CHESTNUT SQUARE

PROJECT GOALS

Reference: **Chestnut Square Drainage**
315 S. Chestnut St.
McKinney, Texas 75069

Reference: **Delaney Cottage**
 303 S. Chestnut St.
 McKinney, Texas 75069

Chestnut Square
McKinney, Texas

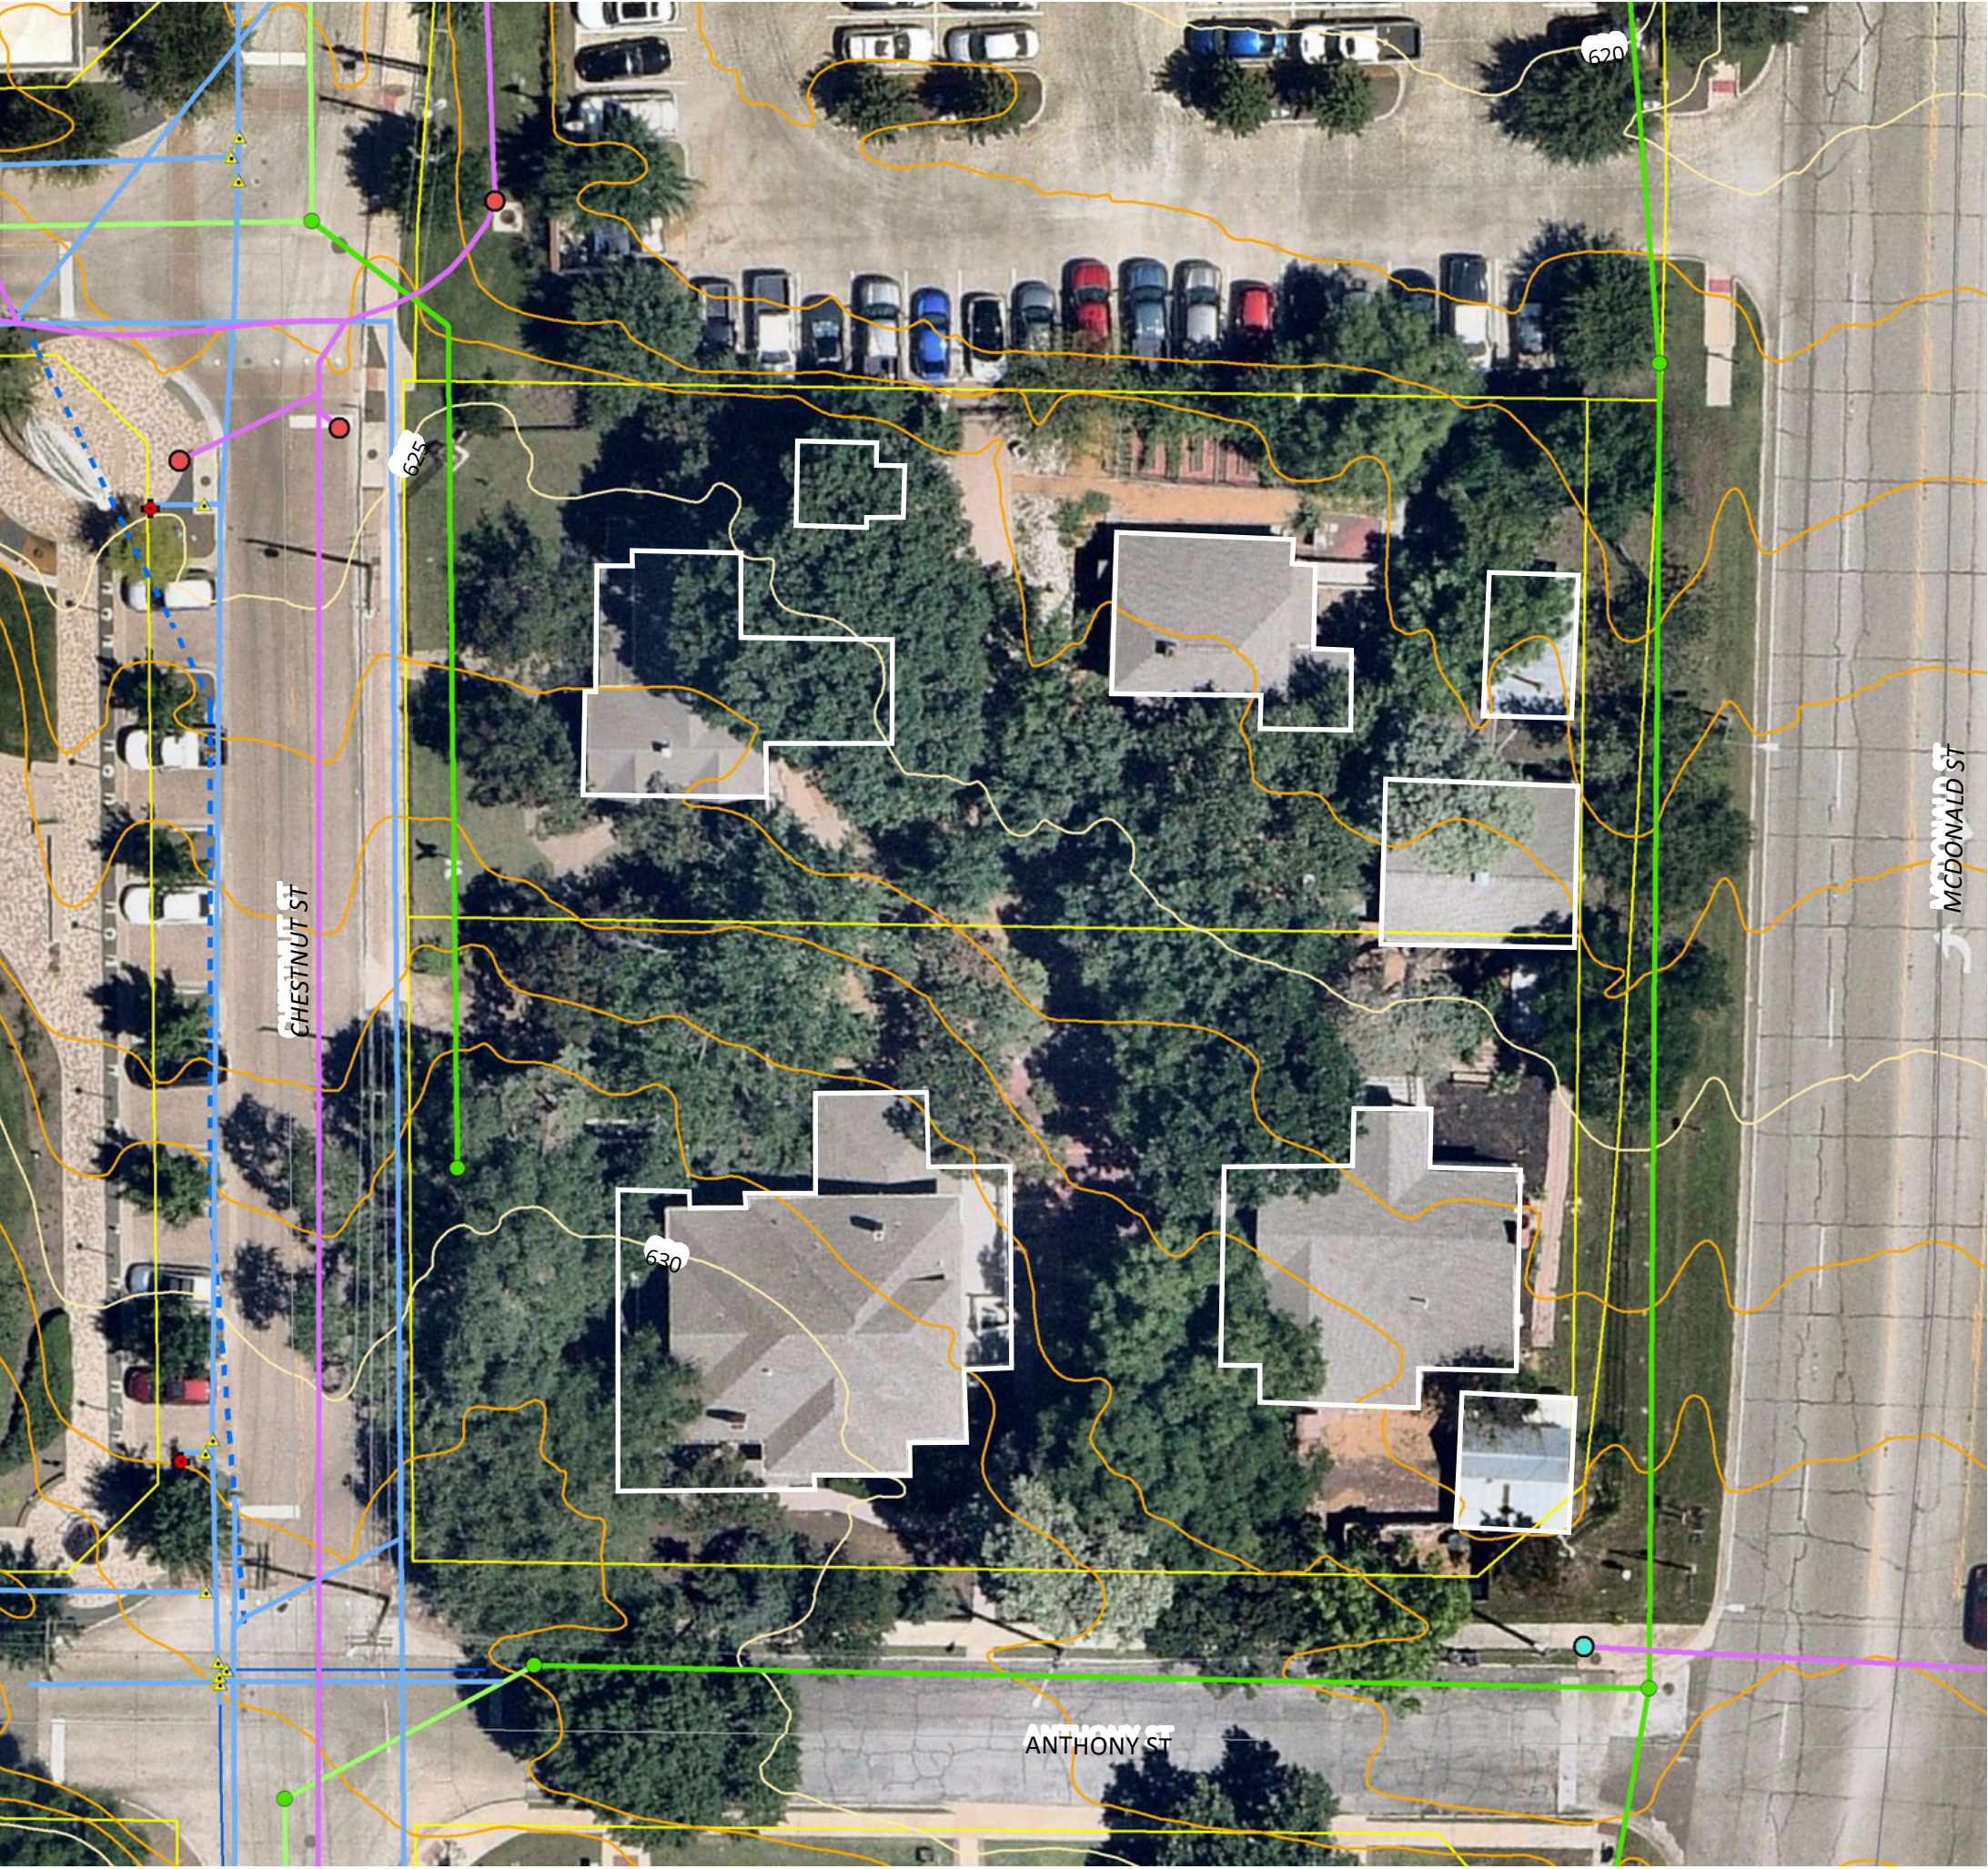
The existing grading plan is attached, and it represents a natural sheet flow runoff pattern from
the southwest to the northeast. We understand there have been some slight adjustments made
to respective grading within the courtyard on the property to divert water around Taylor Inn
located on the northeast side (noted on the attachment). These adjustments include berms
and a river rock collection area which would result in a slight concentration of outfall to the north
in the approximate center of the Square.

The plan to divert runoff around Dulaney Cottage (noted on the attachment) would also result in
slight concentrations of outfall on the east and west sides of the Cottage but would not increase
the total outfall to the north. The parking lot developed to the north side of the Square was
apparently designed to accept the Square outfall and, along with its own surface area collection,
transport it to State Highway 5 and stormwater drains at the intersection of the Highway and
Davis Street.

It is our conclusion that these proposed modifications will improve the drainage on Chestnut
Square while not negatively impacting the surrounding properties.
